ADDENDUM

Addendum Number: 001
Project: Community Hospital MOB 1 PET/CT Remodel
Project Number: 257406.00
Date: March 2, 2026

**COMMUNITY
HOSPITAL MOB 1
PET CT**

**FLOOR PLAN - MEDICAL
GAS**

P3.11

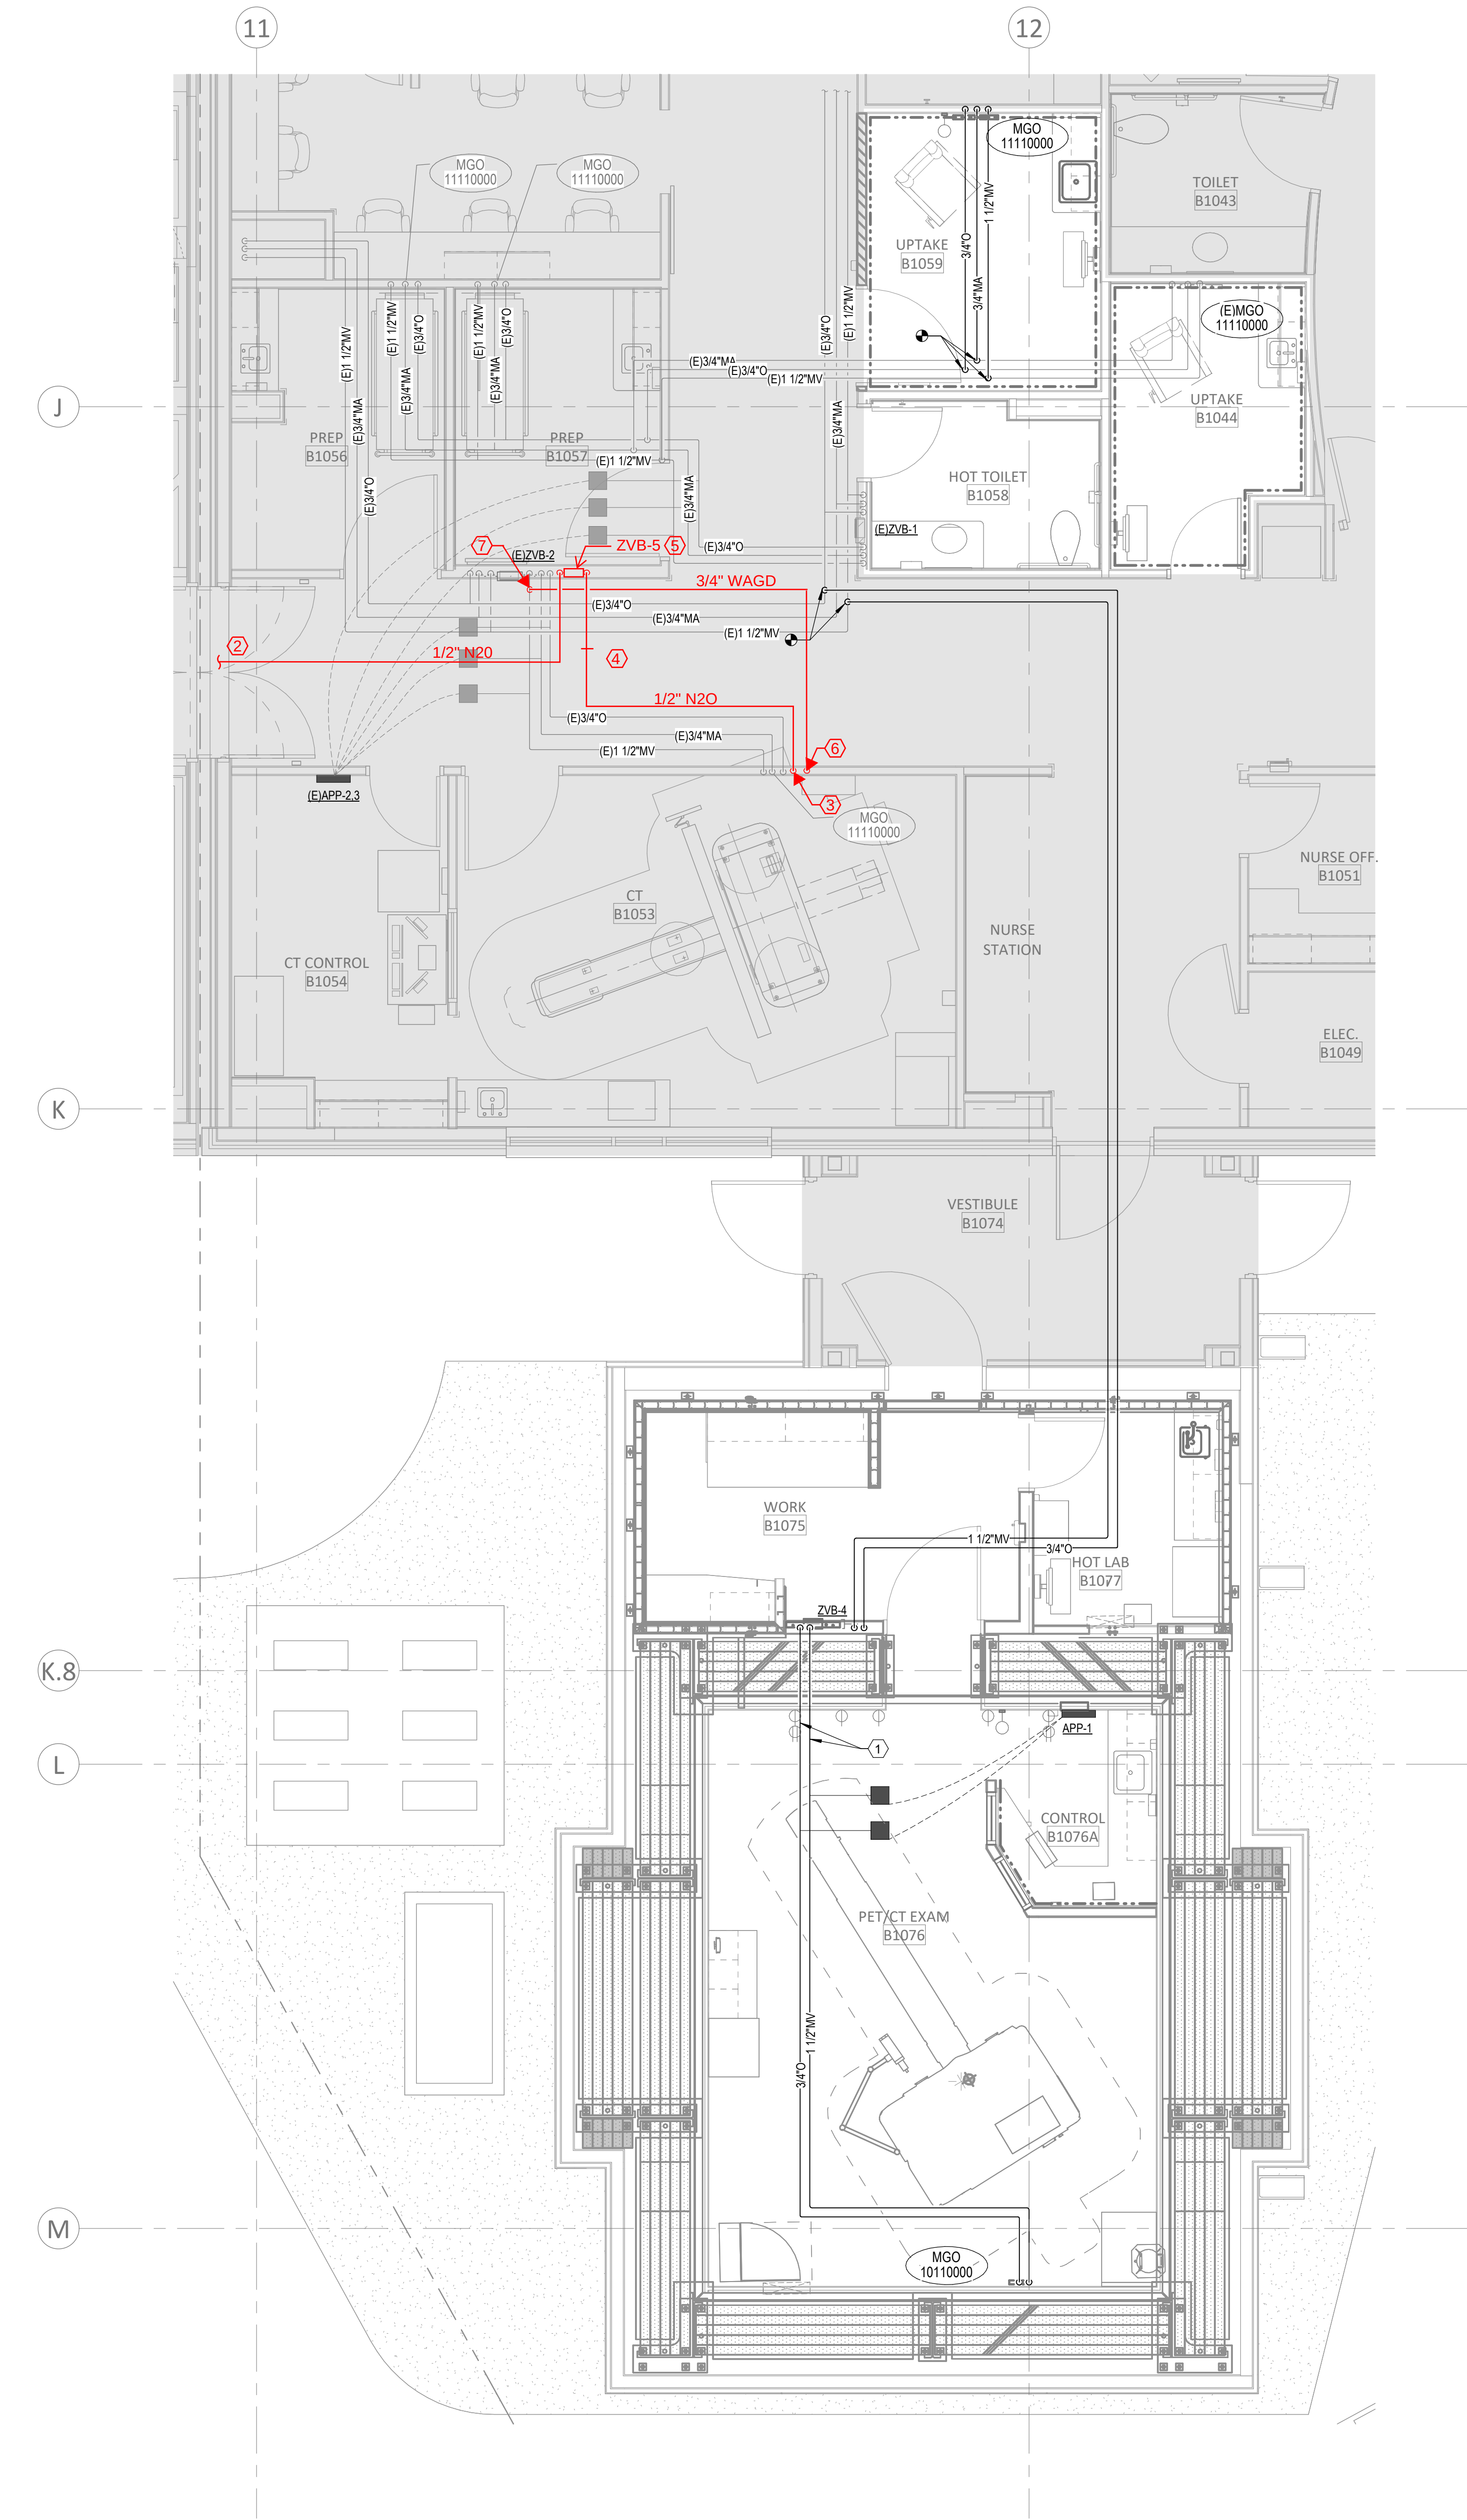
- MEDICAL GAS
 - Add N2O medical gas to room CT B1053 per attached sketch

1. CONTRACTOR TO USE EXISTING PENETRATIONS FROM CONDUIT REMOVAL AS A PATH FOR MEDICAL GASES THROUGH SHIELDING.
2. CONTRACTOR TO CONNECT NEW 1/2" N2O LINE TO EXISTING N2O LINE SERVING CT - 1125 PRIOR TO ZONE VALVE BOX.
3. CONTRACTOR TO EXTEND NEW 1/2" N2O LINE DOWN TO NEW MEDICAL GAS OUTLET. MATCH ALL FINISHES TO WHAT IS EXISTING.
4. CONTRACTOR TO ADD NEW 1/2" N2O LINE TO (E)APP-2.3. MAKE ALL FINAL CONNECTIONS AS PER MANUFACTURER'S RECOMMENDATIONS
5. CONTRACTOR TO EXTEND 1/2" N2O DOWN TO NEW ZVB-5. MAKE ALL FINAL CONNECTIONS AS PER MANUFACTURER'S RECOMMENDATIONS.
6. CONTRACTOR TO EXTEND NEW 3/4" WAGD LINE DOWN TO NEW MEDICAL GAS OUTLET. MATCH ALL FINISHES TO WHAT IS EXISTING.
7. CONTRACTOR TO CONNECT NEW WAGD PIPING LINE TO EXISTING VACUUM LINE. CONTRACTOR TO MAKE NEW CONNECTION AS FAR AWAY FROM EXISTING VACUUM INLET (MINIMUM OF 10').
